HUNTER'S COVE SUBDIVISION, UNIT ONE, PHASE TWO

APPLICATION NUMBER 9 DATE June 15, 2006
 APPLICANT Hunter's Cove Subdivision, Unit One, Phase Two
 REQUEST Subdivision

SUBDIVISION PLAT

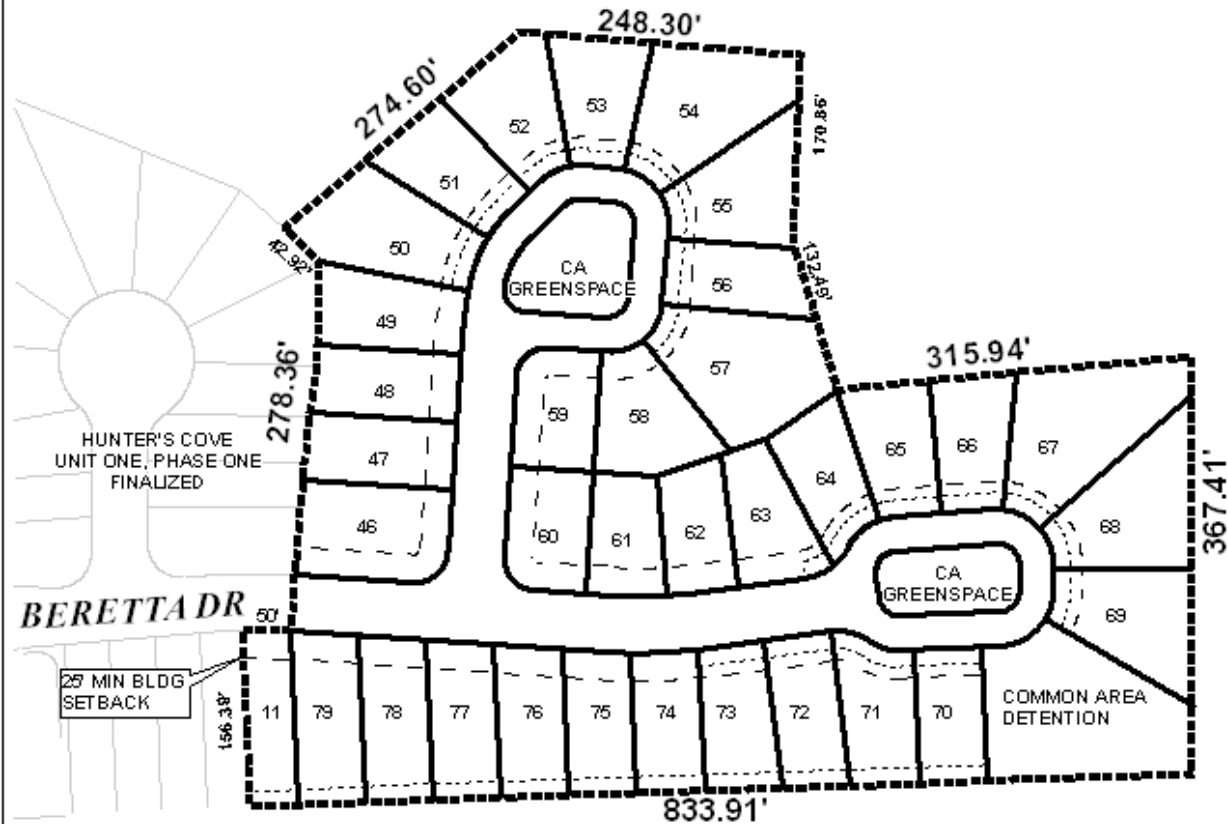
The preliminary plat depicts 35 lots, while the approved 2004 application shows the same area divided into 47 lots. This application increases the size of many of the proposed lots, thus reducing the total number. The proposed street layout remains the same as approved in 2004. Several lots, as proposed, will be less than the minimum required width of 60 feet, and one proposed lot will additionally be less than the required minimum lot size of 7,200 square feet. The original approval for the overall subdivision waived Section V.D.2. of the Subdivision Regulations due to the innovative design of the subdivision, thus a waiver for this application would be appropriate and in keeping with the original approval.

Three common areas are depicted and labeled on the preliminary plat, as is a note stating that maintenance of any common areas will be the responsibility of the development's property owners association: this note should also appear on the final plat, if approved.

The "General Notes" portion of the preliminary plat identifies various utility and drainage easements, which should also be graphically depicted on the drawing.

This site is located in Mobile County, thus a note should be placed on the Final Plat stating that any lots which are developed commercially and adjoin residentially developed property must provide a buffer, in compliance with Section V.A.7. of the Subdivision Regulations.

With a waiver of Section V.D.2., the plat is recommended for Tentative Approval, subject to the following conditions: 1) retaining of common area labeling and notes; 2) graphic depiction of all drainage and utility easements referenced in the "General Notes" section; and 3) placement of a note on the Final Plat stating that any lots which are developed commercially and adjoin residentially developed property must provide a buffer, in compliance with Section V.A.7. of the Subdivision Regulations.
